# Access Compliance Report

## Public Rights-of-Way

Intersection ID: 3738	Main Street: SANDRINGHAM_PL	Cross Street: WITHERSHINN_DR	Location: SE
ADA ID: 7B023C89C598	Ramp Type: Perp	Initial Pass/Fail: Fail	Overall Compliance: No
Severity Score: 8.75			
Codes/Mitigation Info/Possible Solution		Field Measurements/Component Compliance

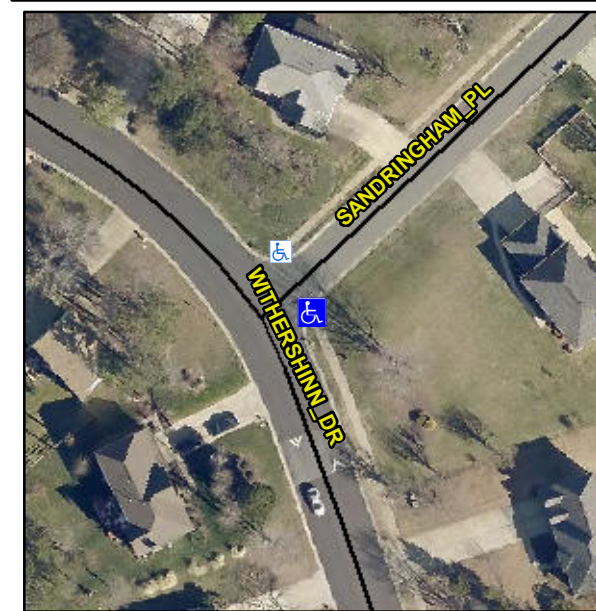
**Remove & Replace Entire Ramp.**

**Not Found, R304.5.1**

Compliance	Description	Data	Compliance	Description	Data
N/A	Ramp Length (in)	46.0	Yes	Ramp Slope (%)	7.8
No	Ramp Width (in)	47.5	Yes	Ramp XSlope (%)	1.0
N/A	Flare Type LT	N/A	N/A	Flare Type RT	N/A
N/A	Flare Slope LT (%)	N/A	N/A	Flare Slope RT (%)	N/A
N/A	Flare Traversable LT?	N/A	N/A	Flare Traversable RT?	N/A
N/A	Landing Length (in)	N/A	N/A	DWS Provided?	N/A
N/A	Landing Width (in)	N/A	N/A	DWS Contrast?	N/A
N/A	Landing Slope (%)	N/A	N/A	DWS Length (in)	N/A
N/A	Landing X Slope (%)	N/A	N/A	DWS Full Width?	N/A
N/A	Landing Curb? (Y/N)	N/A	N/A	DWS Offset (in)	N/A
N/A	Shared Landing?	N/A			
N/A	Gutter Ponding?	N/A	N/A	Gutter Slope (%)	N/A
N/A	Gutter Lip Ht (in)	N/A	N/A	Gutter X Slope (%)	N/A
N/A	Painted X Walk1?	No	N/A	Painted X Walk2?	N/A
	X Walk 1 Direction	To N		X Walk 2 Direction	N/A
N/A	X Walk 1 Width (in)	N/A	N/A	X Walk 2 Width (in)	N/A
	X Walk 1 Slope (%)	1.5		X Walk 2 Slope (%)	N/A
	X Walk 1 X Slope (%)	2.0		X Walk 2 X Slope (%)	N/A
